TRANS/WP.29/973
4 February 2004

World Forum for Harmonization of Vehicle Regulations (WP.29)

DRAFT SUPPLEMENT 6 TO THE 03 SERIES OF AMENDMENTS
TO REGULATION No. 44

(Child restraints)

Figure 1

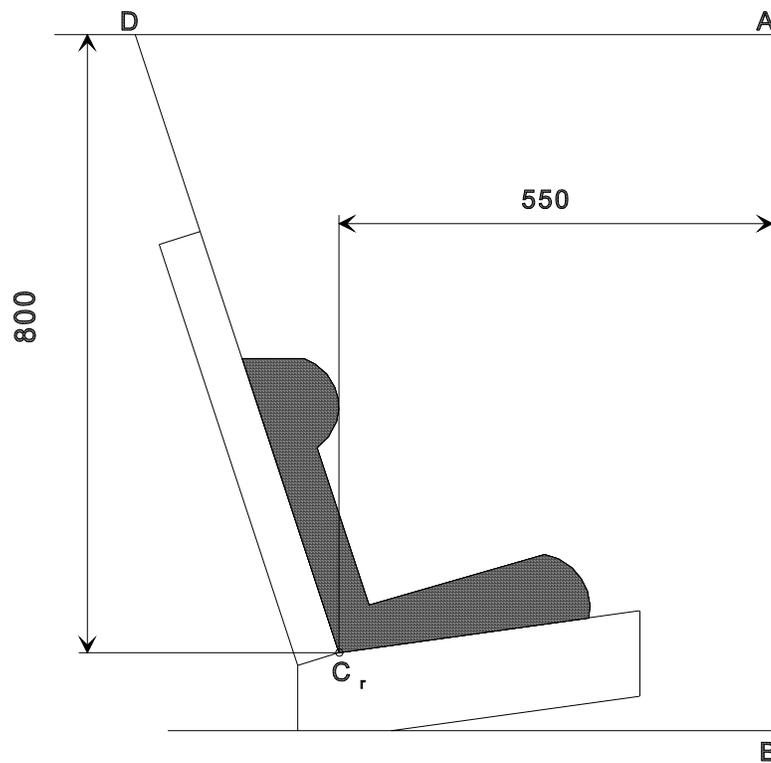
Paragraph 7.1.4.4.1.1., amend to read:

"7.1.4.4.1.1. Forward facing child restraints: the head of the manikin shall not pass beyond the planes BA and DA as defined in Figure 1 below. This shall be judged up to 300 ms or the moment that the manikin has come to a definitive standstill whatever occurs first.

Figure 2:
Arrangement for testing
a rearward-facing device

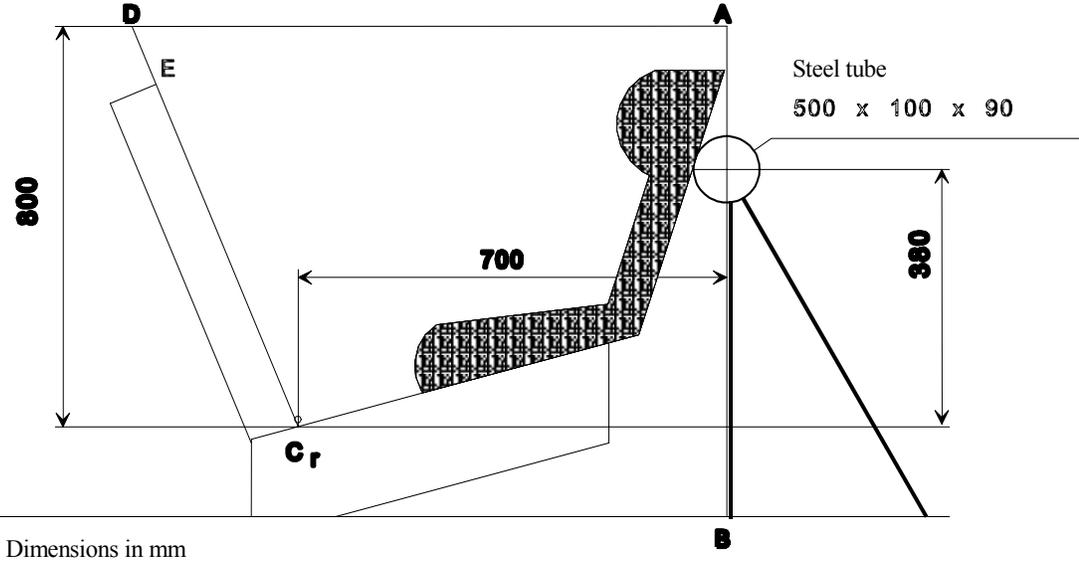
Paragraph 7.1.4.1.2.1., amend to read:

"7.1.4.1.2.1. Child restraints supported by dashboard: the head of the manikin shall not pass beyond the planes AB, AD and DCr, as defined in Figure 2 below. This shall be judged up to 300 ms or the moment that the manikin has come to a definitive standstill whatever occurs first.

Figure 3

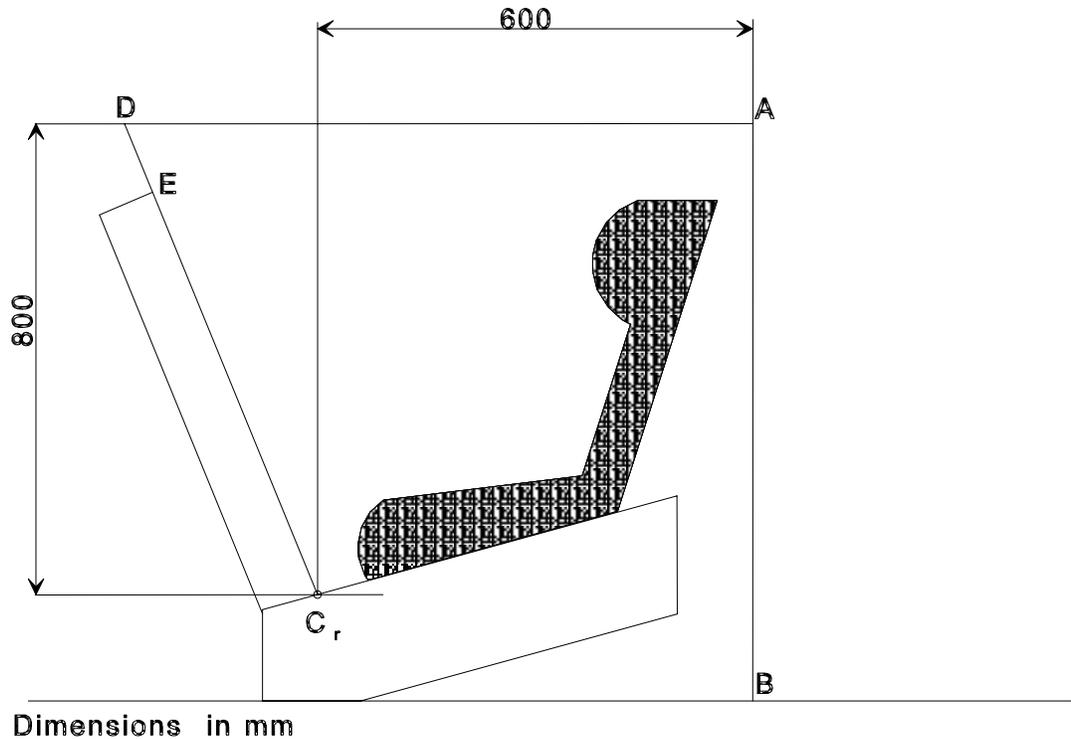
Paragraph 7.1.4.4.1.2.2., amend to read:

"7.1.4.4.1.2.2. Child restraints in group 0 not supported by the dashboard, and carrycots: the head of the manikin shall not pass the planes AB, AD and DE as shown in Figure 3 below. This shall be judged up to 300 ms or the moment that the manikin has come to a definitive standstill whatever occurs first.

Figure 1: Standard seat belt configurations"

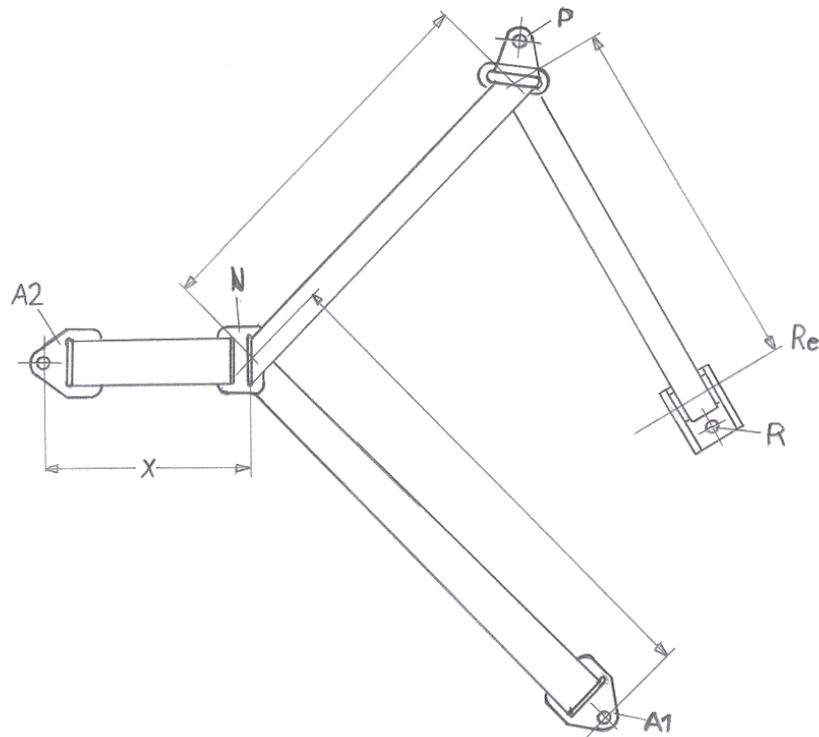
The value of X in Figure 1 below is 200 ± 5 mm. The effective strap length between A1 and the centre-line of the retractor spool Re (when the webbing is fully extracted including the minimum length of 150 mm */ for testing of universal and semi-universal categories shall be 2820 ± 5 mm when measured in a straight line without load and on a horizontal surface; this length may be increased for testing of restricted category; for all categories with the child restraint installed there shall be a minimum of 150 mm */ of strap length on the retractor spool."

Figure 1., amend to read:
